SUBJECT: ARKANSAS NUCLEAR ONE, UNIT NO. 1 - ISSUANCE OF AMENDMENT RE:
UPDATE THE REACTOR COOLANT SYSTEM PRESSURE AND
TEMPERATURE LIMITS AND THE LOW TEMPERATURE OVERPRESSURE
PROTECTION SYSTEM LIMITS (TAC NO. MF5292)

Amendment No. 254
Renewed License No. DPR-51

SAFETY EVALUATION BY THE OFFICE OF NUCLEAR REACTOR REGULATION

ARKANSAS NUCLEAR ONE, UNIT NO. 1

FIGURE 3.4.3-1
RCS Heatup Limitations to 54 EFPY

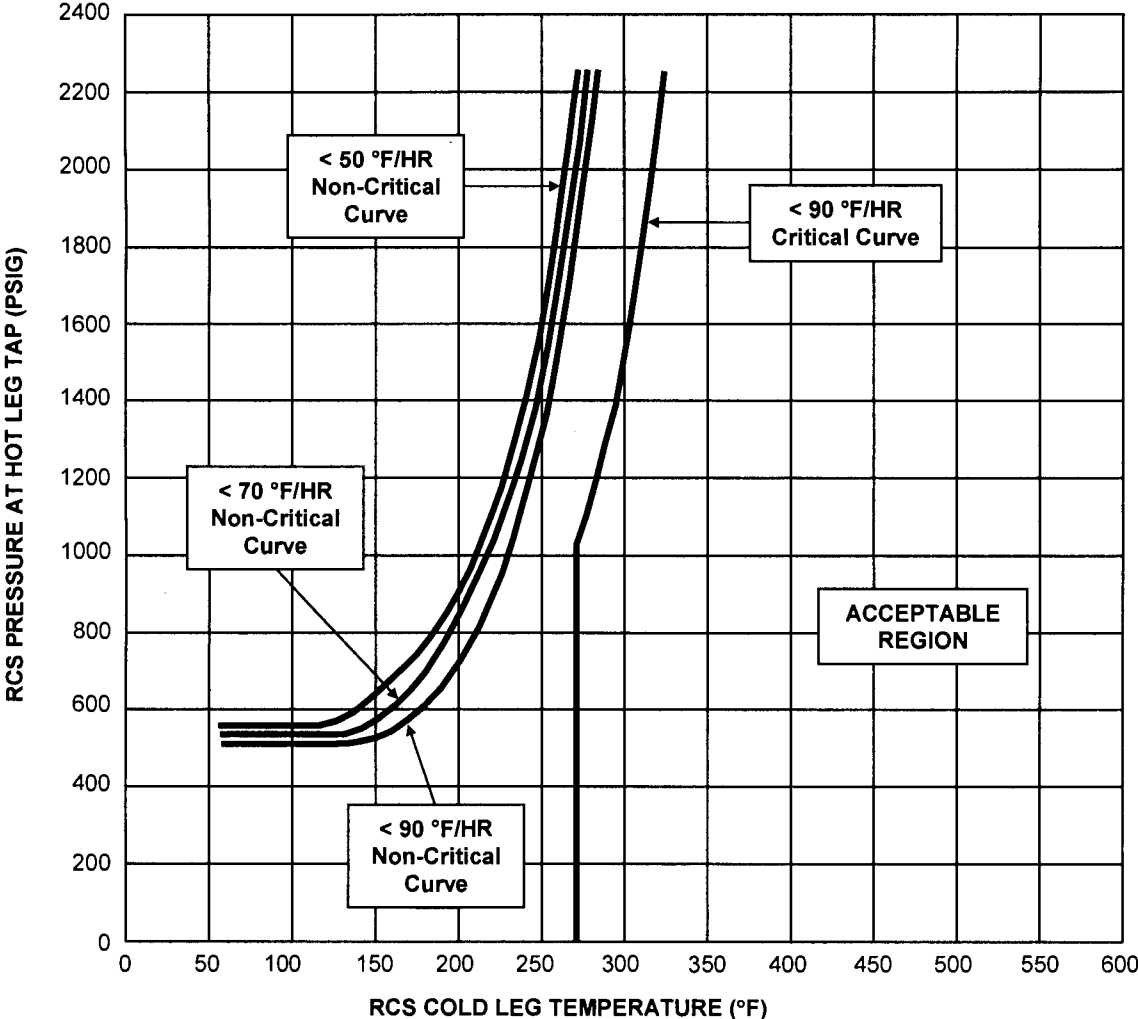
The current title of Figure 3.4.3-1, "RCS Heatup Limitations to 31 EFPY" would be changed to "RCS Heatup Limitations to 54 EFPY."

The changes to the RCS P/T heatup limitations curves in Figure 3.4.3-1 reflect an updated analysis for protection against brittle fracture during plant operation from 31 EFPY to 54 EFPY.

The critical and non-critical curves for the heatup transients are shown in TS Figure 3.4.3-1.

FIGURE 3.4.3-2
RCS Cooldown Limits to 54 EFPY

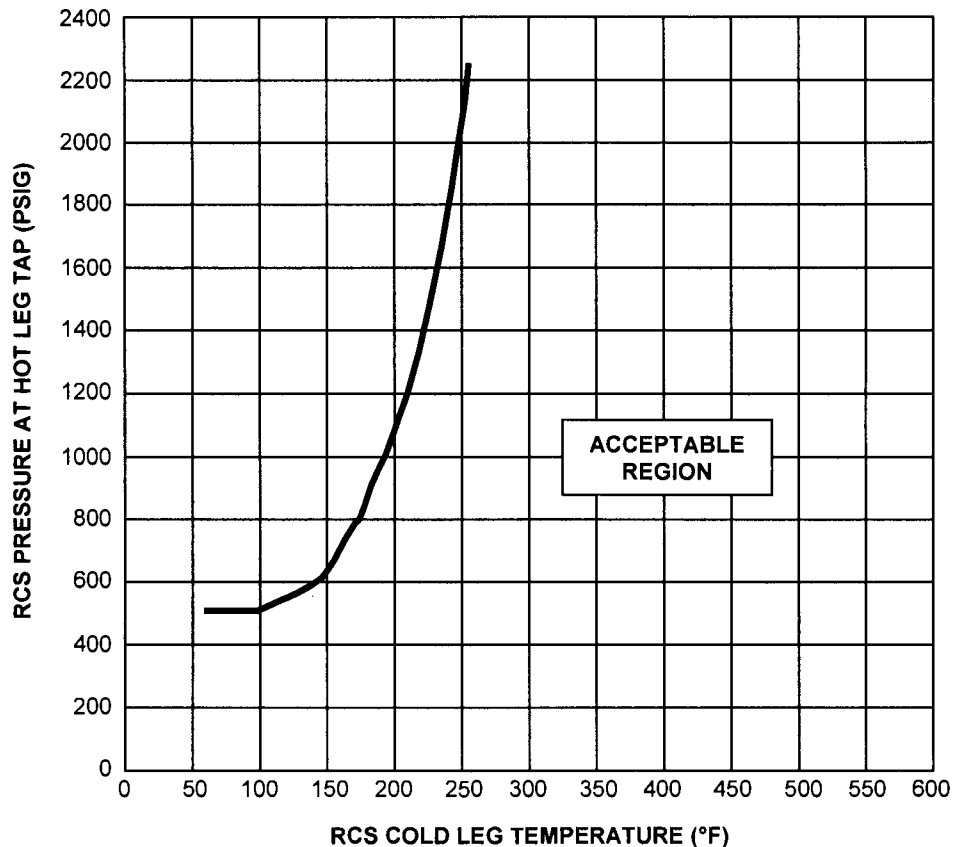
The current title of Figure 3.4.3-2, "RCS Cooldown Limits to 31 EFPY" would be changed to "RCS Cooldown Limits to 54 EFPY."

The changes to the RCS P/T cooldown limit curve in Figure 3.4.3-2 reflect an updated analysis for protection against brittle fracture during plant operation from 31 EFPY to 54 EFPY.

Current Figure 3.4.3-2, Note 3 states:

Revised Figure 3.4.3-2, Note 3 would state:

Current Figure 3.4.3-2, Note 4 states:

Revised Figure 3.4.3-2, Note 4 would state:

Current Figure 3.4.3-2, Note 5, which states "If RCPs are operated < 200 °F, then the RCS cooldown rate from 150 °F ≤ T ≤ 180 °F is reduced to 30 °F in 15 hours," would be deleted.

The licensee also analyzed a step cooldown transient and a ramp cooldown transient. The cooldown curve for these transients is shown in TS Figure 3.4.3-2. TS Figure 3.4.3-2 limits the maximum cooldown rate to 100 °F per hour at temperatures greater than or equal to 280 °F, 50 °F per hour at temperatures below 280 °F down to 150 °F, and 25 °F per hour at temperatures below 150 °F. The licensee analyzed both ramp and step transients to determine the most limiting P/T curve. The TS also limit the maximum step temperature changes as follows: at temperatures greater than or equal to 280 °F, 50 °F in any one-half hour, at temperatures less than 280 °F down to 150 °F, 25 °F step in any one-half hour, and at temperatures below 150 °F, a maximum step change of 25 °F in any 1 hour.

<u>RCS TEMP</u>	<u>C/D RATE</u>	<u>STEP CHANGE</u>
T ≥ 280 °F	100 °F/HR	≤ 50 °F in any 1/2 HR
280 °F > T ≥ 150 °F	50 °F/HR	≤ 25 °F in any 1/2 HR
T < 150 °F	25 °F/HR	≤ 25 °F in any 1 HR

FIGURE 3.4.3-3
RCS Inservice Hydrostatic Test H/U & C/D Limits to 54 EFPY

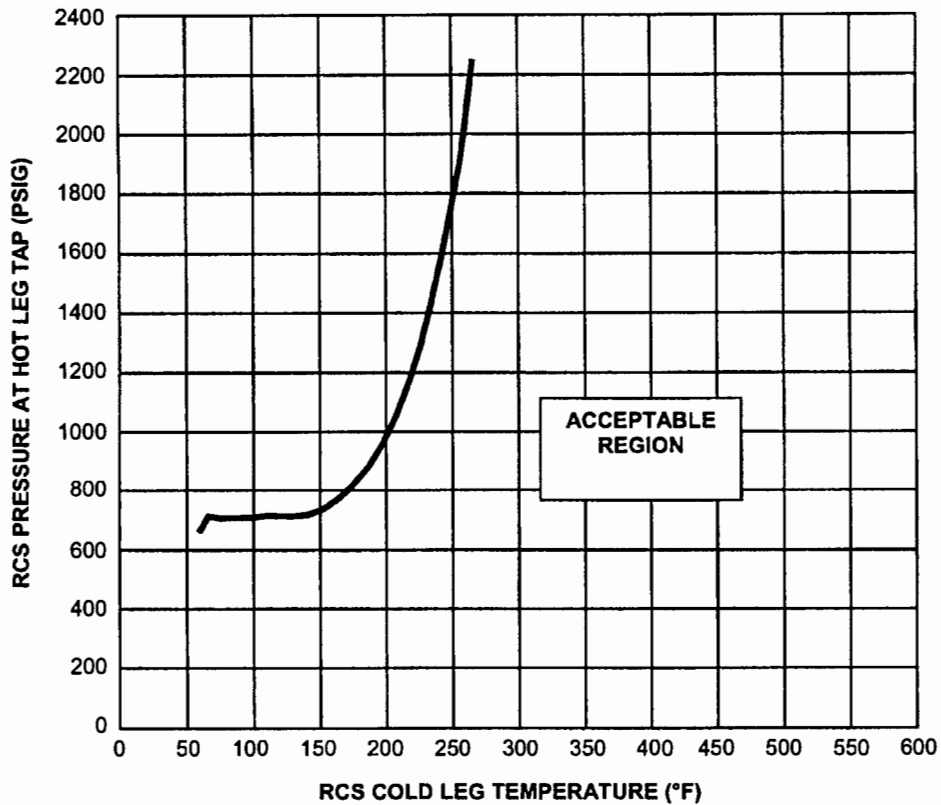
The current title of Figure 3.4.3-3, "RCS Inservice Hydrostatic Test H/U & C/D Limits to 31 EFPY" would be changed to "RCS Inservice Hydrostatic Test H/U & C/D Limits to 54 EFPY."

The changes to the RCS inservice hydrostatic test heatup and cooldown limits curve in Figure 3.4.3-3 reflect an updated analysis for protection against brittle fracture during plant operation from 31 EFPY to 54 EFPY.
